# Intel Technical Advisory

TA-1005-1

## Intel® Integrated RAID Module rework to resolve an AC power cycling cache backup issue

**Figure 1. The jumper wire on Intel® Integrated RAID Module RMS25PB080, RMS25PB040 and RMT3PB080**

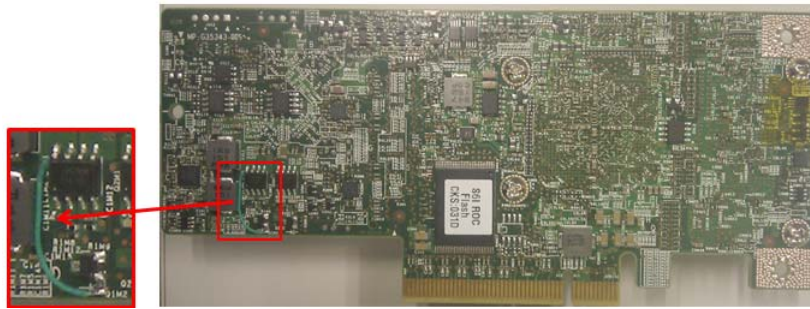
The PCB's (Print Circuit Boards) for the controllers listed above are being modified to resolve an AC power cycling cache backup issue with the Intel® RAID Smart Battery AXRSBBU9 and the Intel® RAID Maintenance Free Backup Unit AXRMFBU2 cache backup solutions. In addition to some minor component changes a jumper wire will be added to the PCB's during manufacturing. Intel has completed product qualification for the changes to verify that there is no impact to product quality and reliability.

See the photos below of the jumper wire on the Intel® Integrated RAID Modules:

The component changes and jumper wire are an interim solution. A new version of the PCB has been designed that incorporates the necessary changes and the new PCB is scheduled for availability in July 2012. Intel does not anticipate any functional nor quality impact with the jumper wire solution. If the jumper wire solution is not acceptable, please order the new modules with the changes designed into the PCB solution, new MM# for the new revision of these products are listed below.
